March 20, 2024

Re: **Initial Submission Review -** High Point Dollar General – Site Plan Amendment  
**Case Number:** 2021-6056-02

HIGH POINT - DOLLAR GENERAL  
SITE PLAN

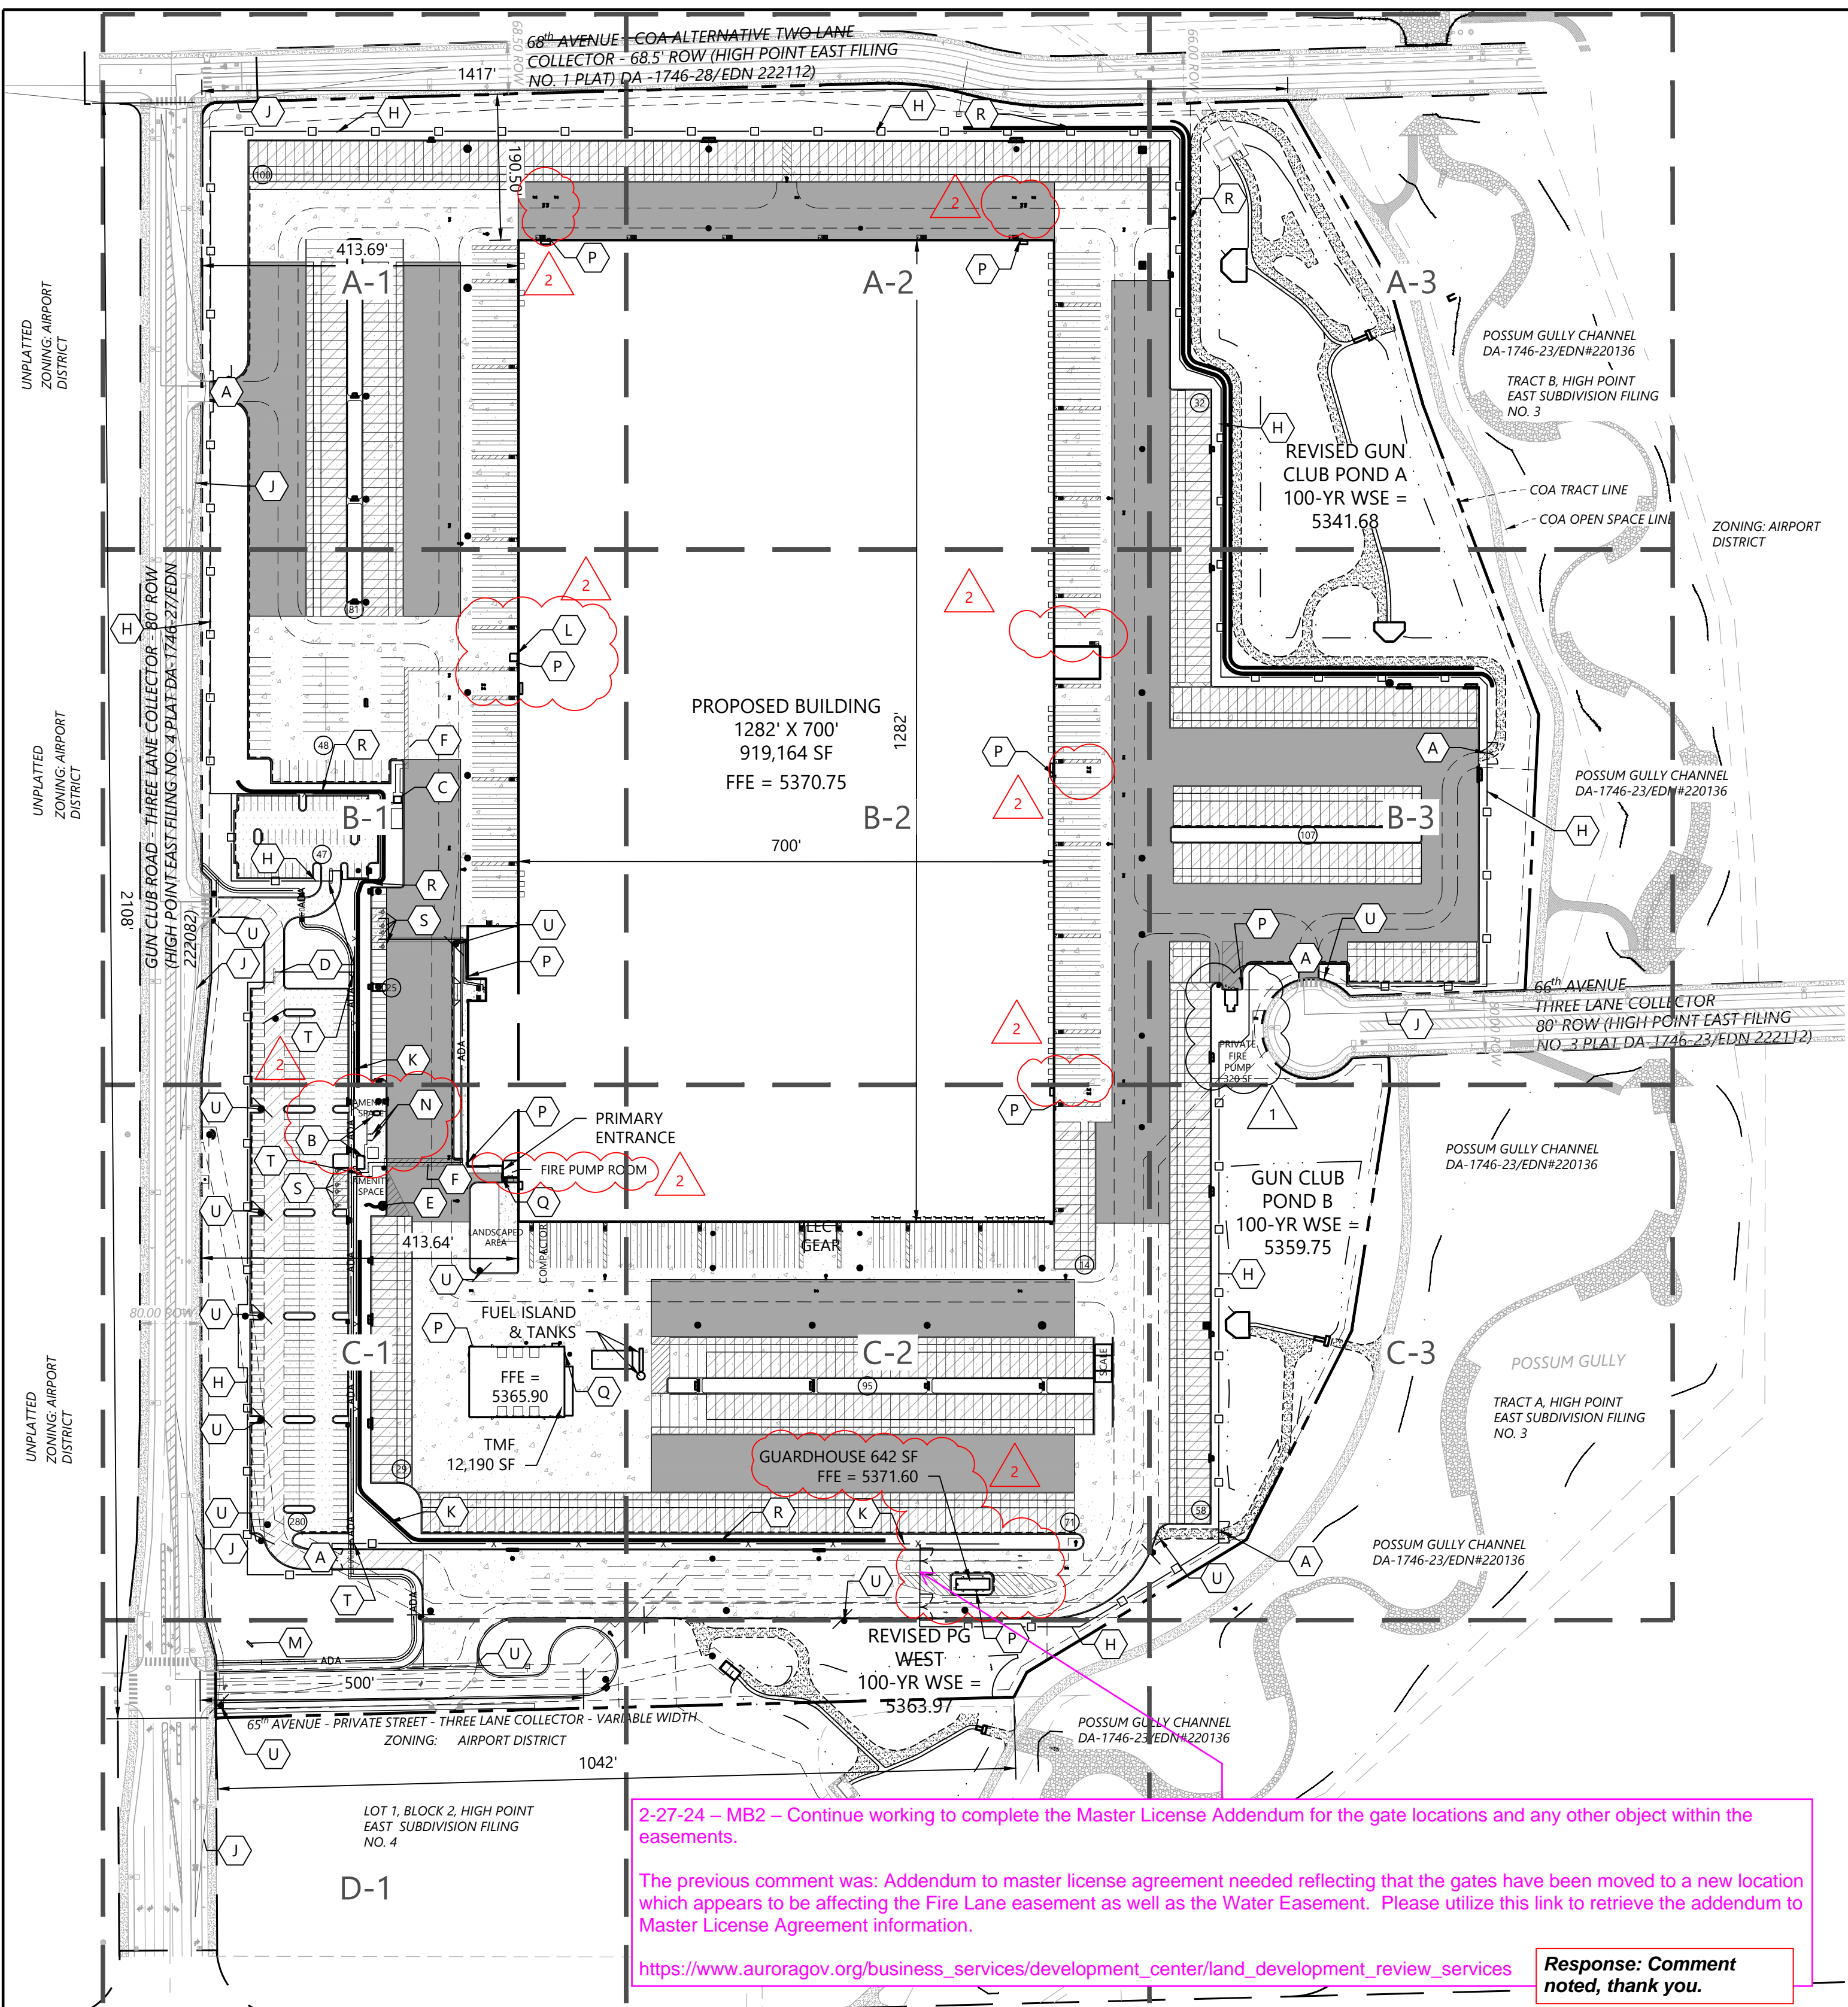
2-27-24 - MB2 - Continue working to complete the Master License Addendum for the gate locations and any other object within the easements.

The previous comment was: Addendum to master license agreement needed reflecting that the gates have been moved to a new location which appears to be affecting the Fire Lane easement as well as the Water Easement. Please utilize this link to retrieve the addendum to Master License Agreement information.

Response: Comment noted, thank you.

HYDRO ZONE MAP

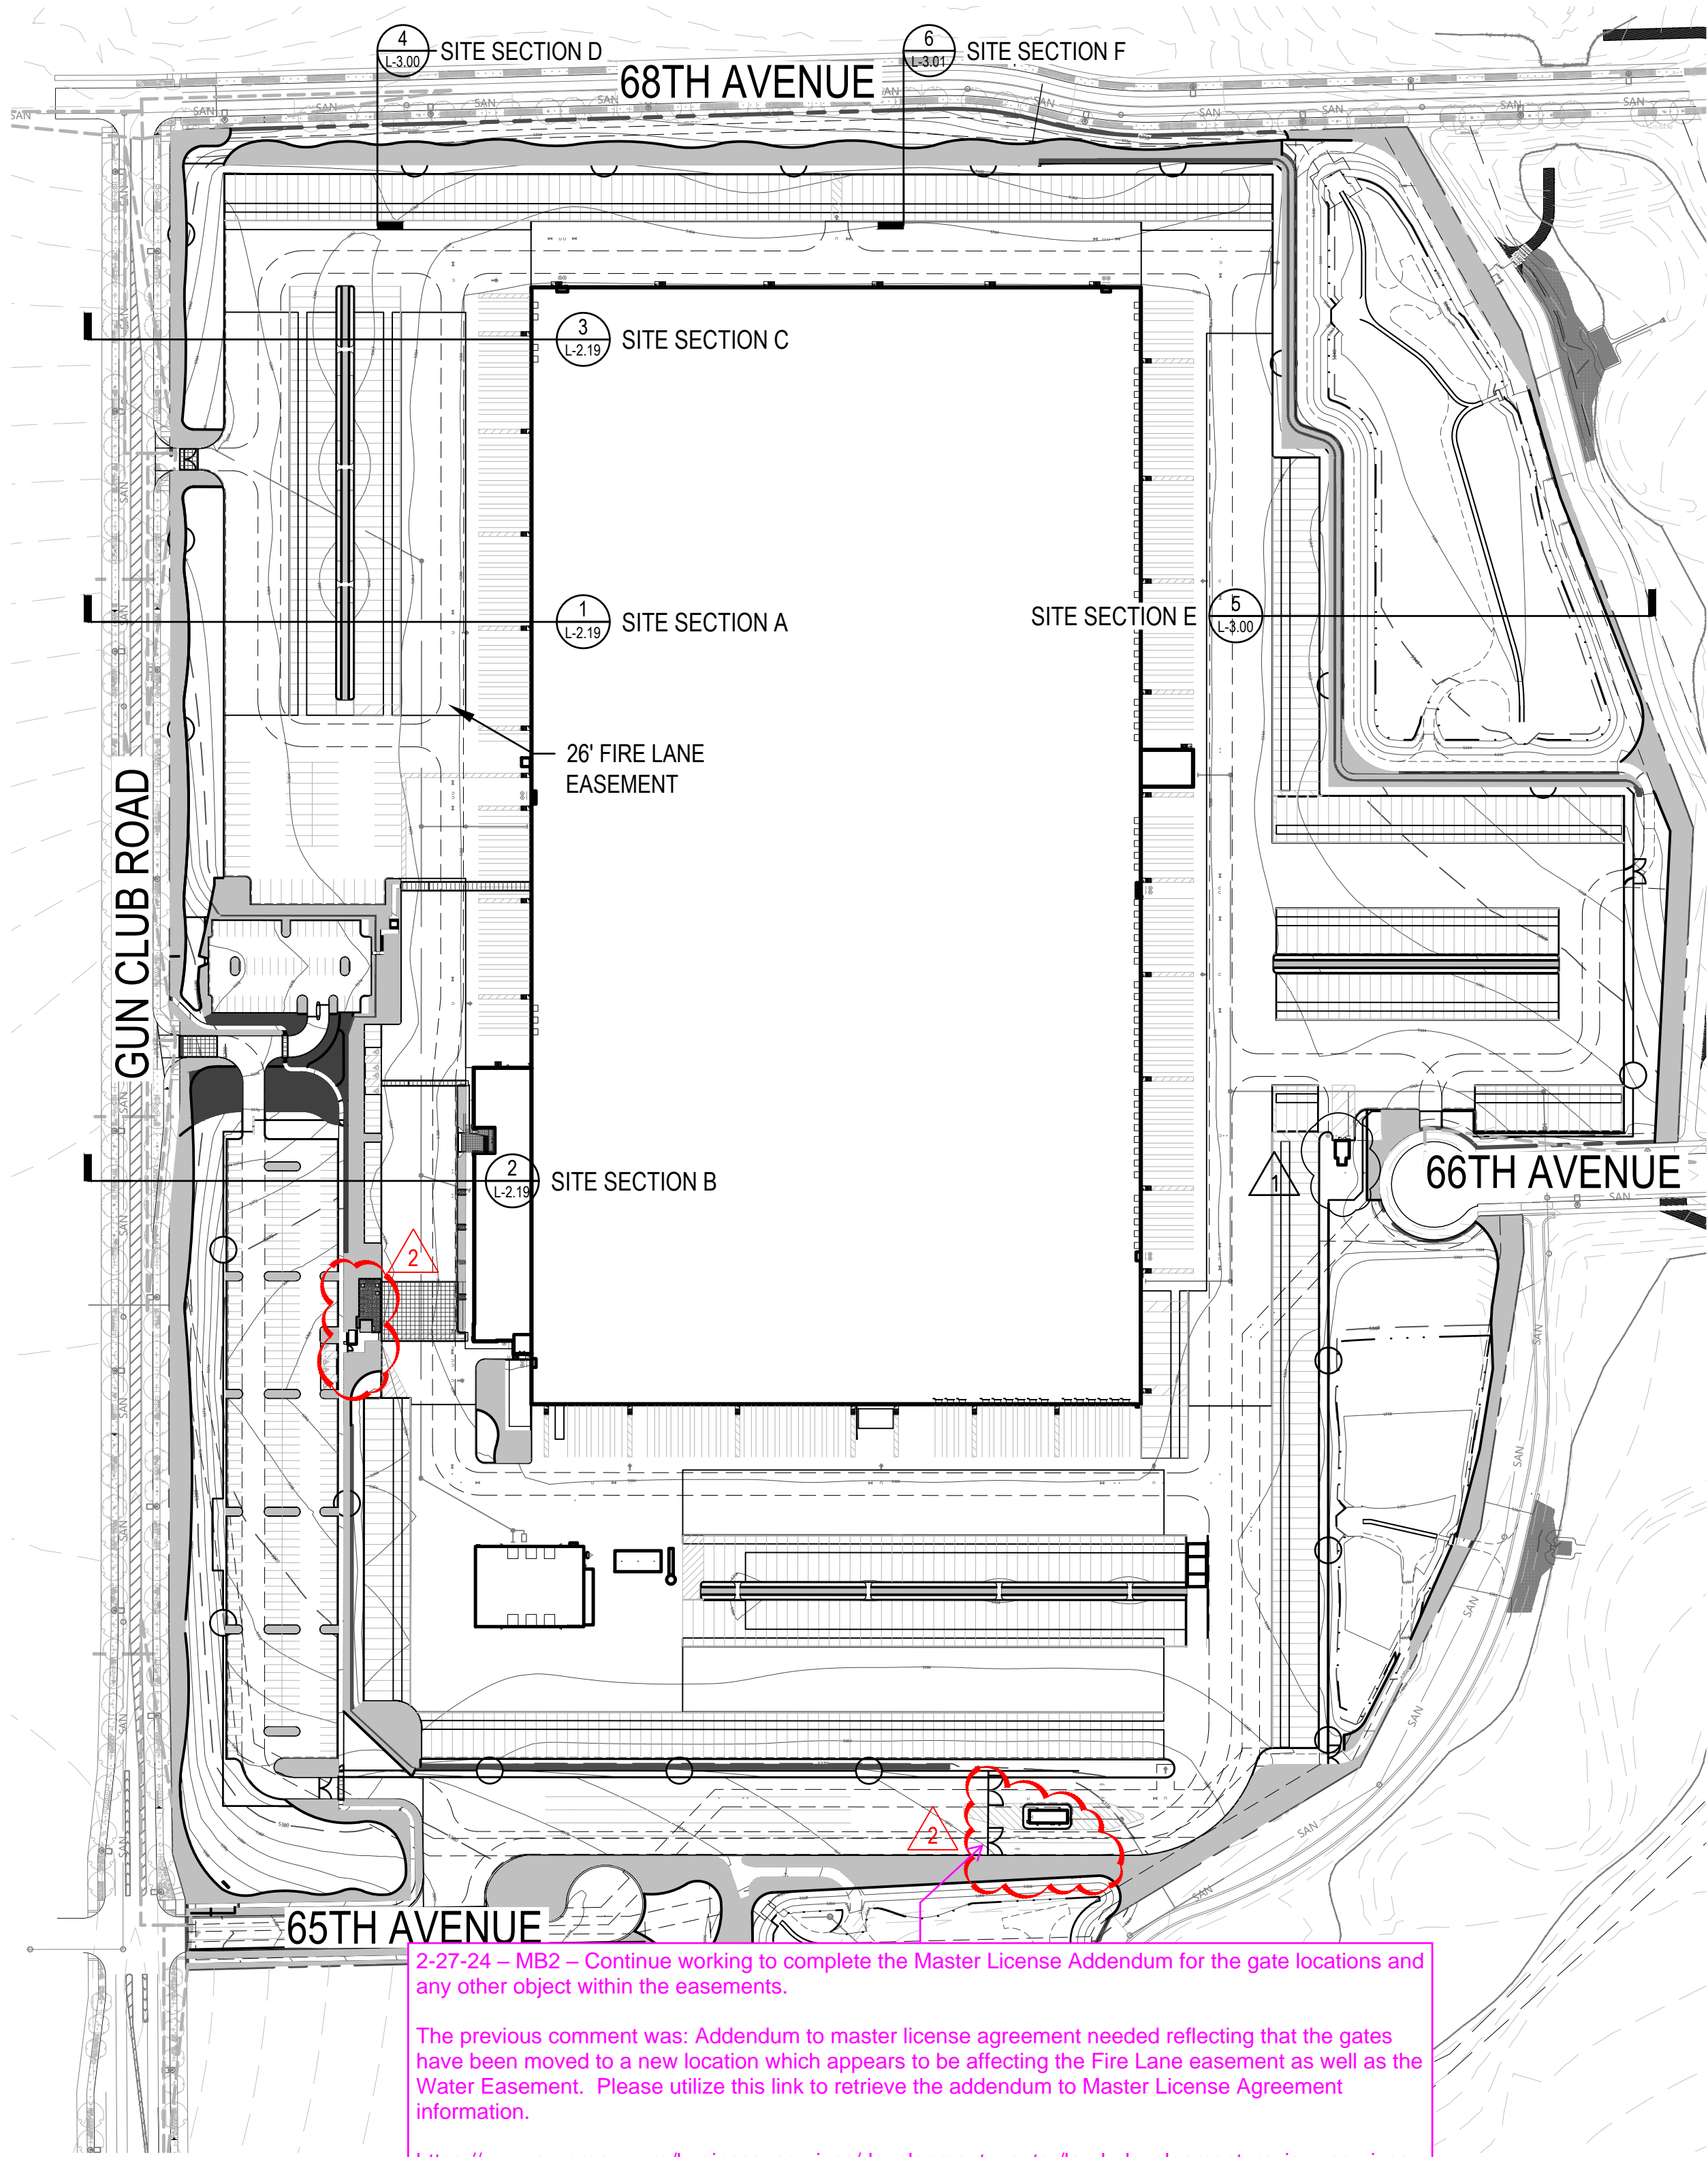
2-27-24 – MB2 – Continue working to complete the Master License Addendum for the gate locations and any other object within the easements.

The previous comment was: Addendum to master license agreement needed reflecting that the gates have been moved to a new location which appears to be affecting the Fire Lane easement as well as the Water Easement. Please utilize this link to retrieve the addendum to Master License Agreement information.

Response: Comment noted, thank you.
